## Interpreting The Secretary of the Interior's Standards for Rehabilitation

**Subject:** New Entries on Mill Buildings

November 2004, ITS Number 30

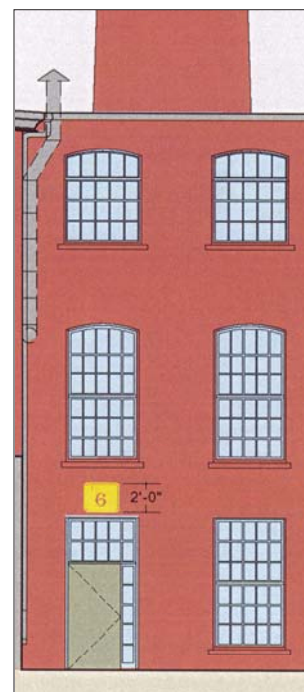
**Application 1 (Compatible entrance):** The buildings in this 19th century mill complex are being converted to a combination commercial/residential use. The plans called for commercial or office space occupying the first floor with apartments above as well as townhouse units with independent entries. In an effort to keep the industrial character of the buildings as conveyed with the large multi-paned windows and even fenestration, the new entrances were introduced by extending the existing historic window openings. Steel entrance doors, some solid and some with multi-paned glazing, were installed. Glazed transoms with a paned configuration to match the adjacent windows surmounted the doors. When the openings were wider than the standard 3'-6", a multi-paned glazed sidelight was also installed. Both treatments are compatible and, thus, meet the Standards.

*Existing historic window openings were extended to allow the installation of new pedestrian entrances. Multiple-paned glass transoms and surrounds matching the historic grid pattern were used to keep the sense of historic glazing.*

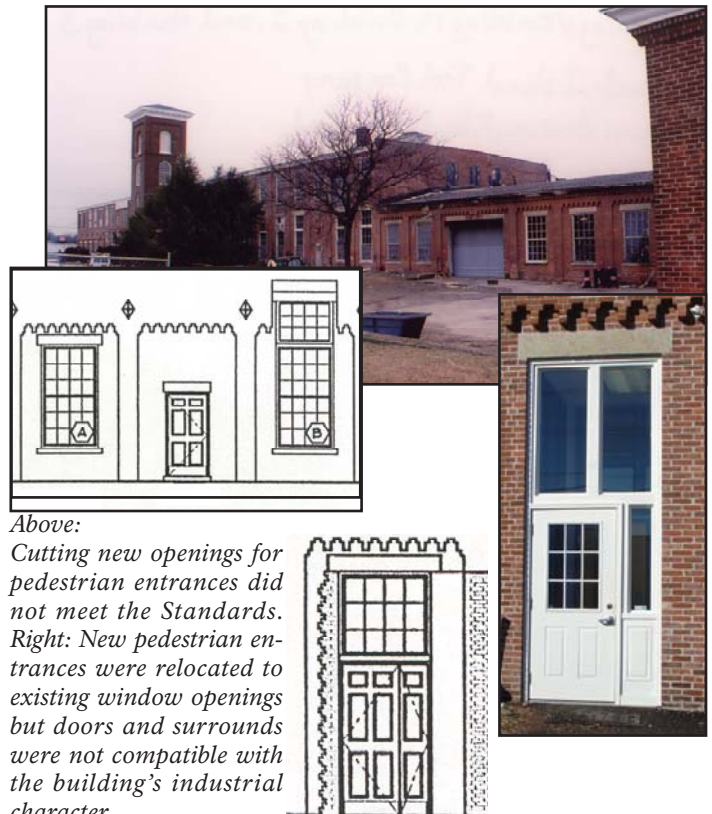
**Application 2 (Compatible entrance):** Another example where compatible new pedestrian entrances were added to historic mill buildings can be seen in this early 20th century complex. The new residential plan called for single-loaded corridors with interior residential entries as well as new entrances on an exterior wall. The existing historic window openings were much wider than those in the previous example. As a result, double-glazed doors with multi-paned glass, surmounted by an arched glazed transom with a pane configuration matching the adjacent windows, were installed. This treatment allowed for new exterior entrances while keeping the historic fenestration pattern and, therefore, met the Secretary of the Interior's Standards for Rehabilitation.

*Existing historic window openings were extended to allow for the new below-grade pedestrian entrances. In order to keep the important historic fenestration pattern, double doors with multi-paned glazing, surmounted by a glazed transom, were installed. The pane configuration of both the door and transom units matched that of the adjacent windows.*
